Washer Hose Loose

Section Wiper/Washer

YEAR(S)	MODEL(S)	ADDITIONAL INFORMATION
2009 – 2010	Corolla

Figure 1.

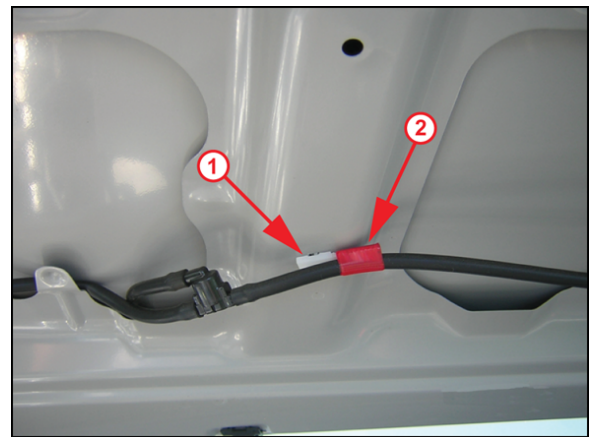
1. Remove the red tape holding the windshield washer hose to the hood clip, as shown in Figure 1.
 - A. Remove the clip from the hood.
 - B. Remove the tape by cutting.

Figure 2.

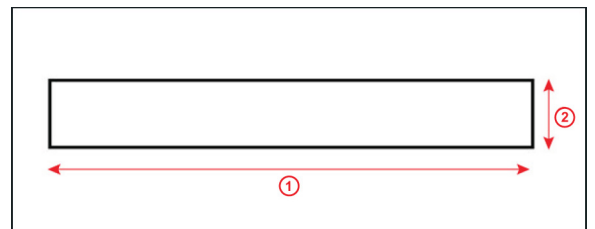
2. Cut the tape into 3 separate pieces to the following dimensions:
 - Length: 90 mm (3 5/8 in.)**
 - Width: 19 mm (3/4 in.)**

Figure 3.

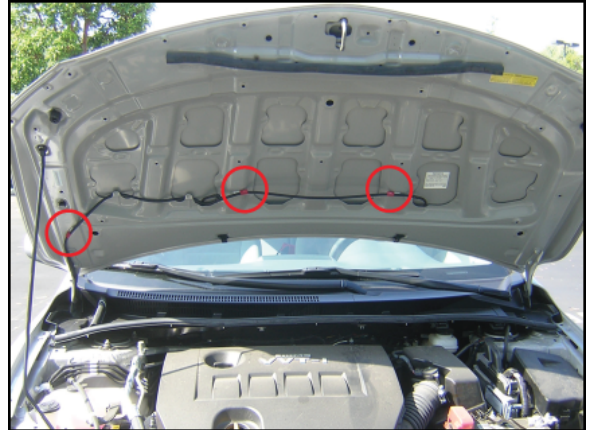
3. Reattach the washer hose to the clip by wrapping it a minimum of 3 turns using NEW tape.

Perform this repair in the 3 locations shown in Figure 3.
